APPENDIX 5 OTHER MATTERS

PEAT LANDSLIDE HAZARD RISK ASSESSMENT

Craiginmoddie WF

STAGE 2 CHECKING REPORT

Drawing Title: **Geomorphological Map**

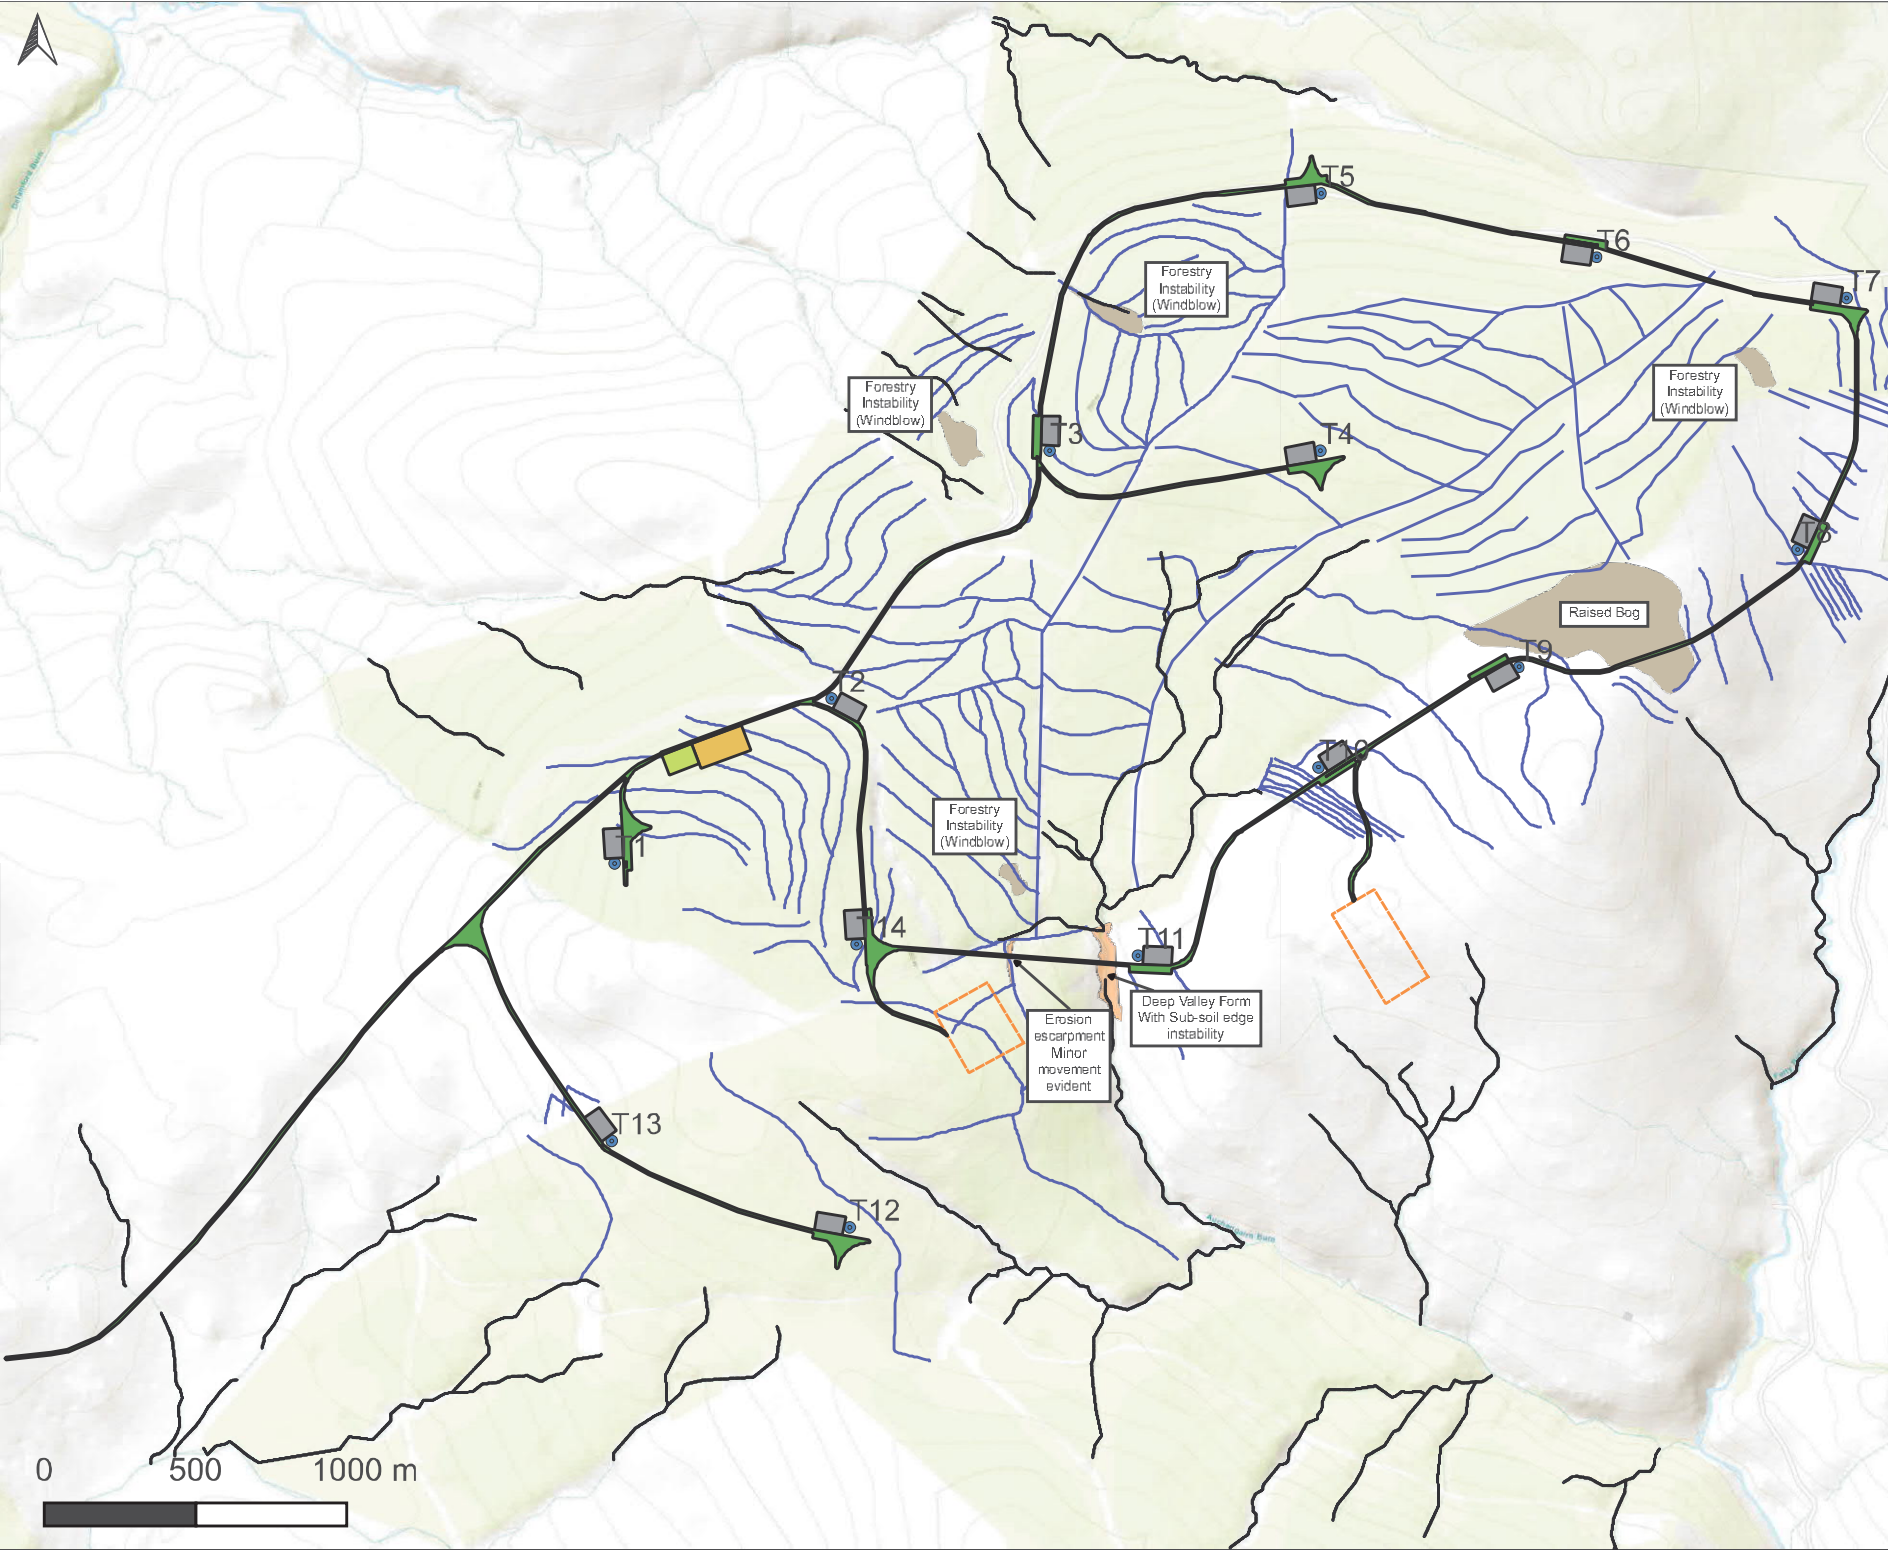
No.	Stage 1 Checking Report Comment	Developer Response	Stage 2 Checking Report Comment	Recommendations
1	The geomorphological mapping should be reviewed to confirm it is in line with ECUBPG, eg. does it include major slope breaks, and updated if not."	The geomorphological map was completed to ensure all visible salient features were highlighted and considered by the risk assessment. Natural Power consider it to be in line with the relevant guidance. Generally, break in slopes although present in the few pronounced incised valley forms were determined not to be key to the risk outcomes in this case. Aerial photography information was reviewed as part of the PLHRA which provided a robust background to the assessment relative to peat landslide risks. This was supported by multiple site reconnaissance surveys undertaken by geotechnical engineers and hydrologists. It is highlighted that widespread commercial forestry plantation obscures a large proportion of the terrain, the focus of the risk assessment was on identification of salient features: watercourses, topography, instability (included on the existing mapping) to inform the risk assessment. In addition, the geomorphological map highlights the key features within the site which may contribute to or signify potential future instability. Natural Power considers the geomorphological information to be adequate for the purposes of the peat slide risk assessment in this case.	Noted aerial photography review and multiple site visits fed into the assessment and forest cover obscures much of the terrain but that the Consultant is satisfied the geomorphological information is adequate for the purposes of the peat slide risk assessment.	No further action.
